Objection to DC/26/0972 and DISC/26/0255

I object to DC/26/0972 (Appearance, Landscaping, Layout and Scale) and DISC/26/0255 (Biodiversity Enhancement Strategy) on the grounds of environmental law and NPPF non-compliance.

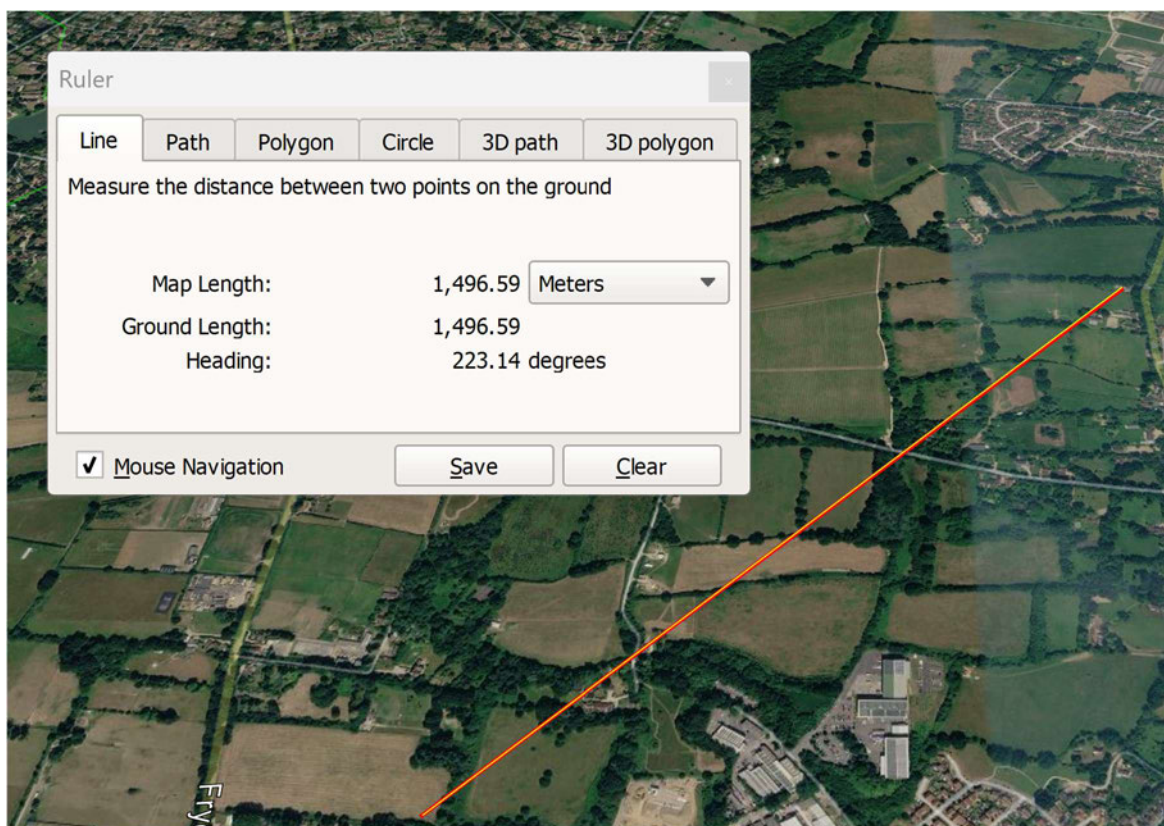
The eastern boundary is a hedgerow interspersed with mature trees – see the photo below taken from the adjacent field.. It will not provide contiguous, year-round screening. The current design will result in domestic and vehicle lights from the houses in the SE corner of the development being visible over a wide area to the North-East and East, especially after leaf-fall.

The design and access statement highlights the presence of Grade II Listed East Wantley Farmhouse and Barn approximately 250m away to the NE of this corner of the development. These heritage assets currently enjoy an ‘intrinsically dark landscape’ with only 4 lights visible across the wider 360 degree landscape. This is demonstrated by the photo taken from East Wantley Barn in the winter. Only 1 light is visible (extreme left) across the southern view towards Melton Drive, with the Orion constellation clearly seen.
